# SAN FRANCISCO PLANNING DEPARTMENT

**DATE:** July 11, 2008  
**TO:** Interested Parties  
**FROM:** Joan A. Kugler, Senior Environmental Planner  
**RE:** CASE NO. 96.281E: CENTRAL SUBWAY PROJECT (PHASE 2 OF THE THIRD STREET LIGHT RAIL PROJECT) COMMENTS AND RESPONSES

**RESPONSE TO COMMENTS**  
**VOLUME II**  
**FINAL SUPPLEMENTAL ENVIRONMENTAL IMPACT STATEMENT/  
SUPPLEMENTAL ENVIRONMENTAL IMPACT REPORT**

FIGURE 2-16

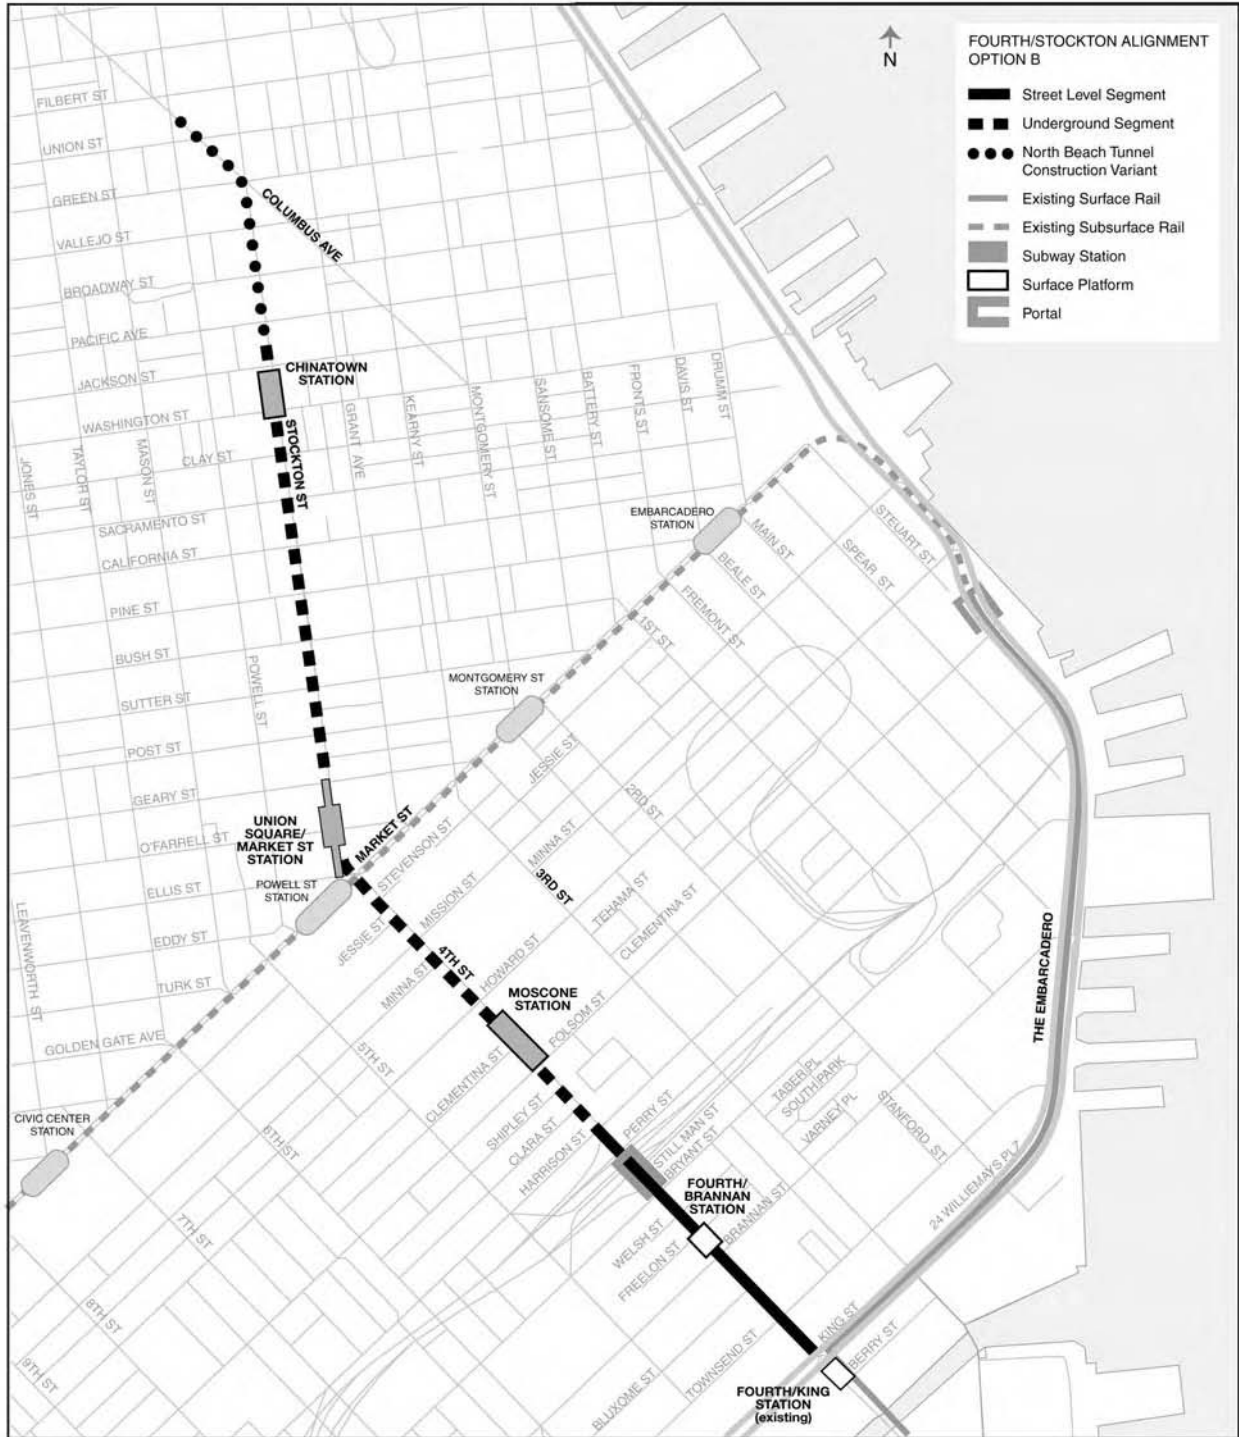
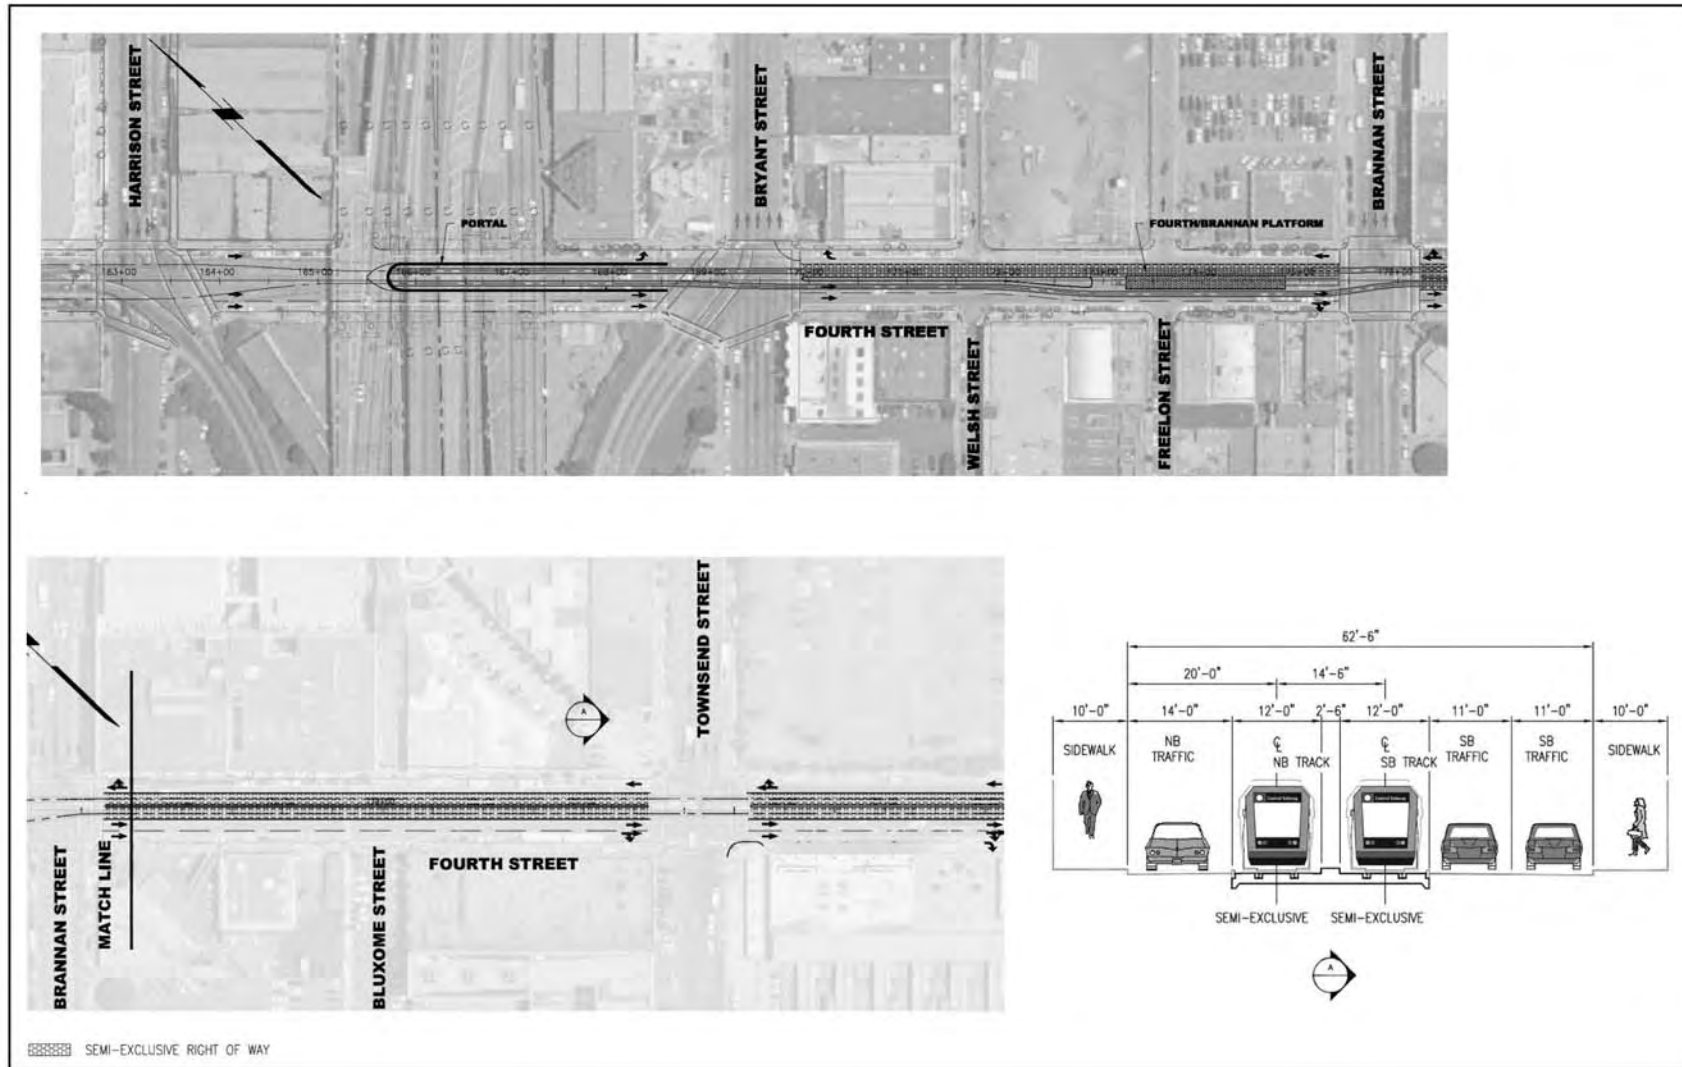
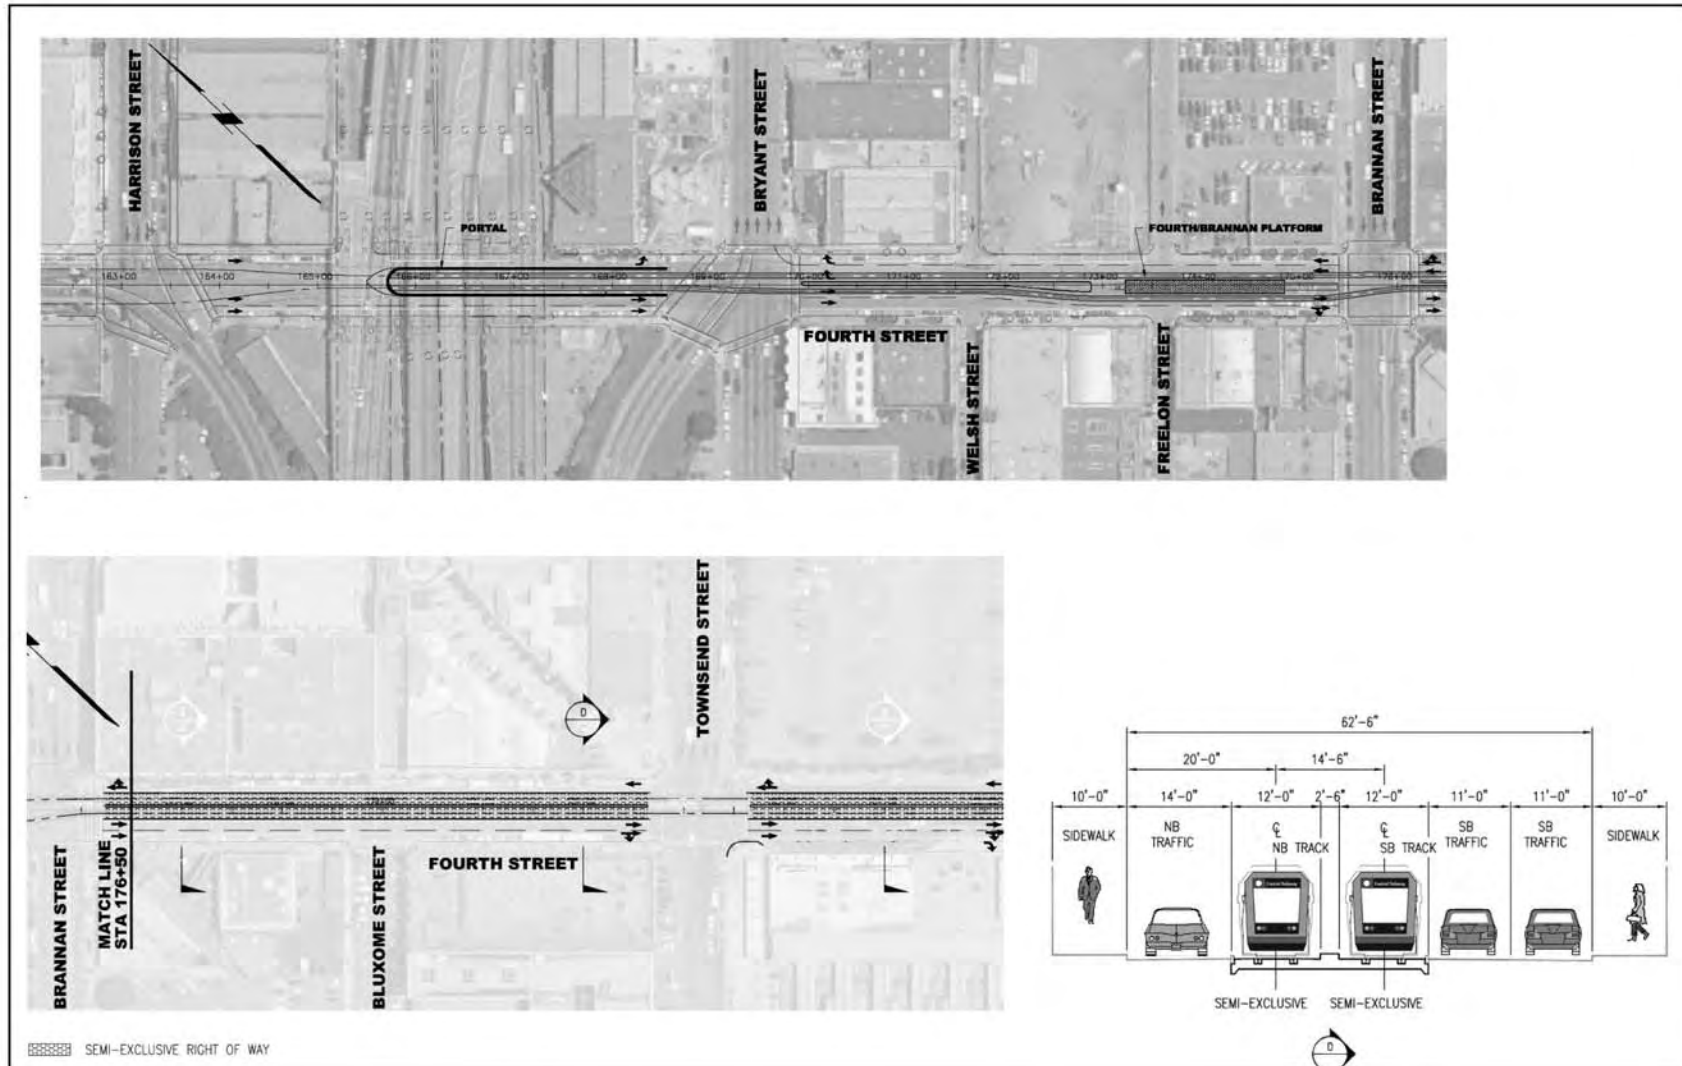
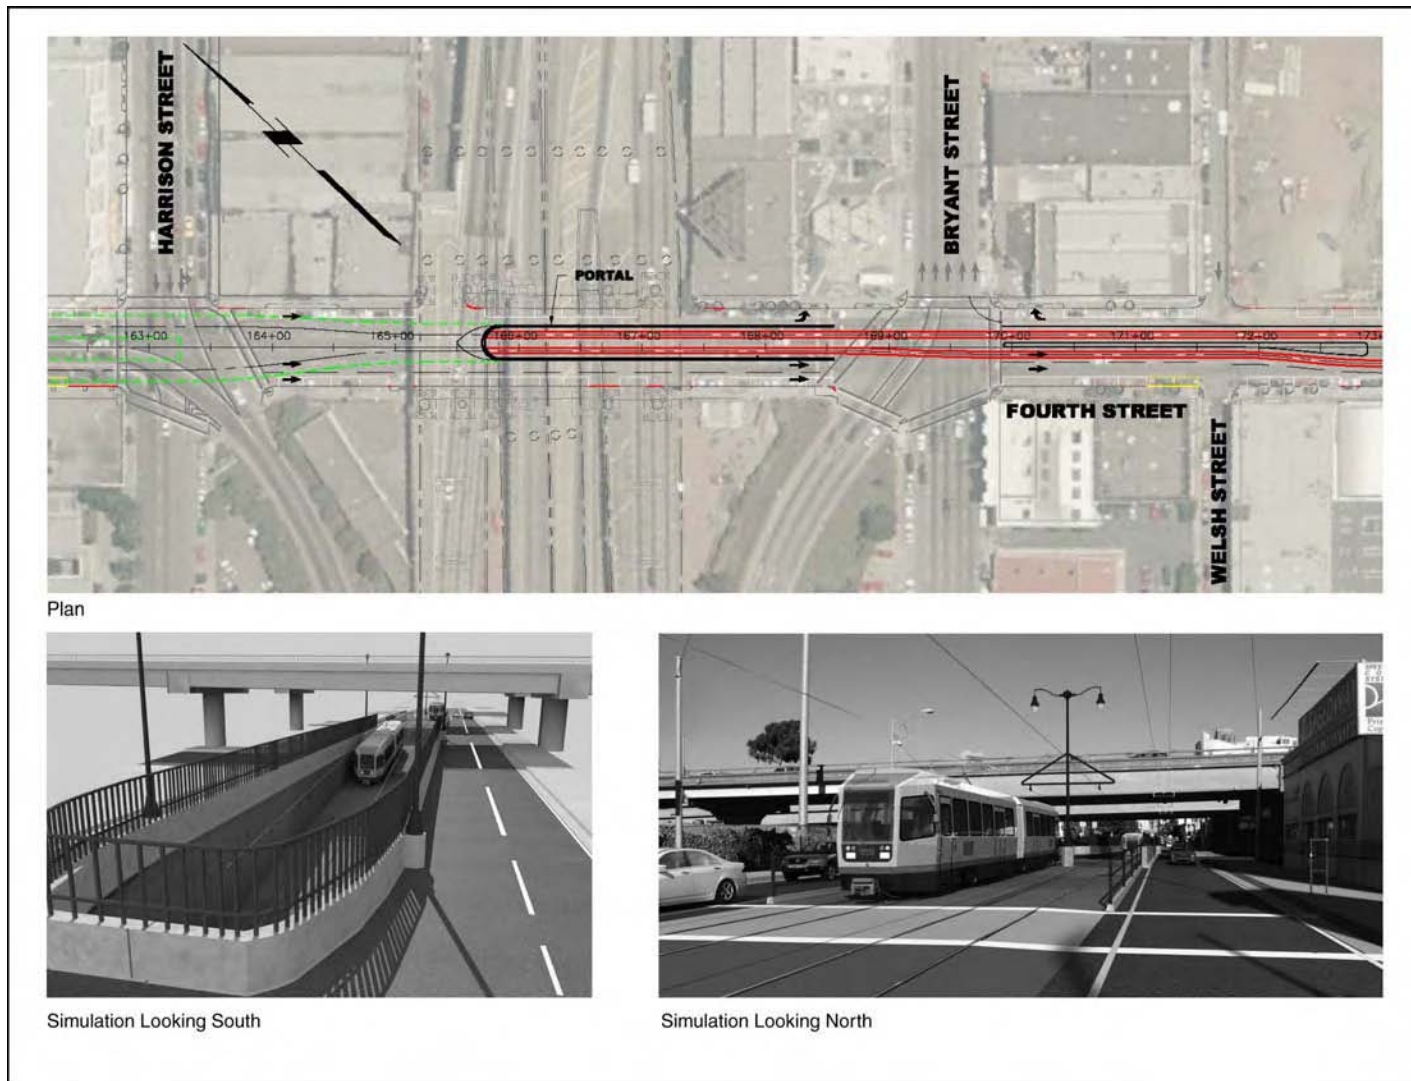
A crash barrier is planned for the portal to protect the entrance structure from turning buses. The current tunnel portal layout plans provide space for the tunnel crash barrier without interfering with the turning path of the bus as it enters the bus storage facility. Figure 2-18 on page 2-39, Figure 2-19 on page 2-41, and Figure 5-10 on page 5-40 have been revised to show the tunnel crash barrier. See Response to Comment R-1 for revised figures.

“After stopping at the station platform on Fourth at King Streets, light rail would continue north on Fourth Street to a double-track portal between ~~Bryant Perry~~ and Harrison Streets under I-80 (see Figure 2-16).”

Figures 2-16, 2-18, 2-19 and 5-10 are revised as noted in the attached pages to reflect the relocation of the subway portal and the placement of a crash barrier.

Figure 4-4

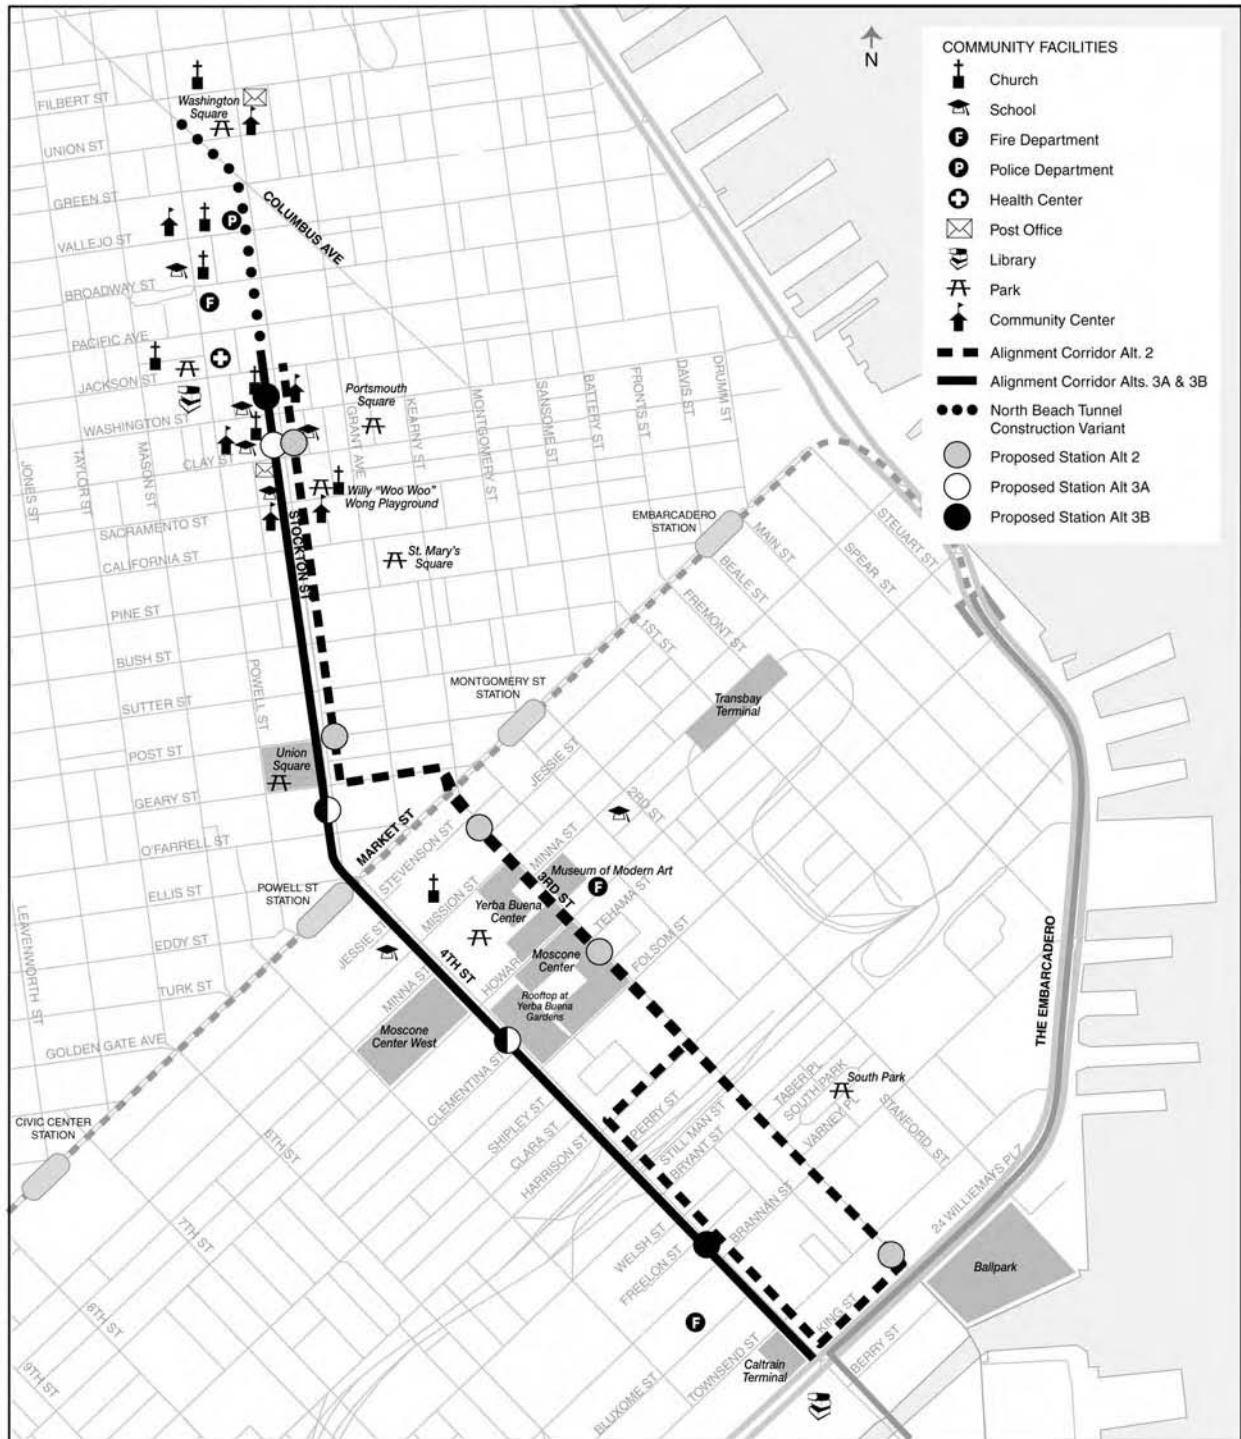
Chinese Hospital	845 Jackson	Private	Medical services
Cumberland Presbyterian Chinese Church	865 Jackson	Private	Presbyterian church
Station 2	1340 Powell	City	Fire house
Gordon Lau Elementary School	950 Clay	SF Unified School District	Elementary School
Salvation Army Chinatown Corps	1450 Powell	Private	Sunday school, senior center, community center
Central Police Station	766 Vallejo	City	Police station
Cathay Post #384 American Legion	1524 Powell	Private	Veterans association
Pin Yuen Senior Recreation Center	799 Pacific	Private	Senior center
San Francisco Chinese Baptist Church	1524 Powell	Private	Baptist church
Chinese United Methodist Church	1009 Stockton	Private	Methodist church

Figure 4-4 on page 4-36 is amended to include the Chinese Historical Society, Donaldina Cameron House, Chinatown YMCA, First Chinese Baptist Church, and Presbyterian Church in Chinatown.
